Replacement of 2492203 with 2492211

Textar aims to streamline the designation of 2492203 to 2492211.

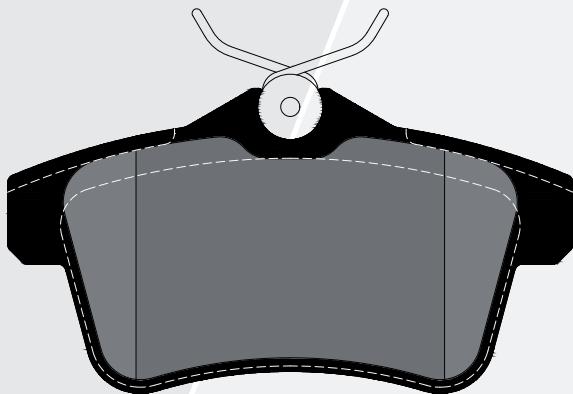
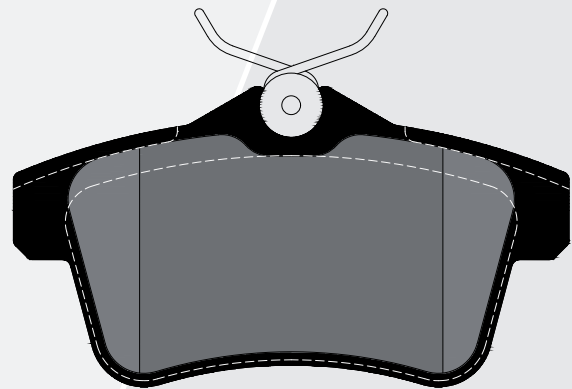
Given the identical outer dimensions of the brake pads we can ensure seamless assembly and operation.

The difference between 2492211 and 2492203 is the 2492211 thickness is slightly thinner.

This consolidation extends coverage to a broader range of vehicles under a singular reference, namely 2492211 which is already covering applications of both part numbers.

The current inventory of 2492203 can be effortlessly marketed and sold without any complications.
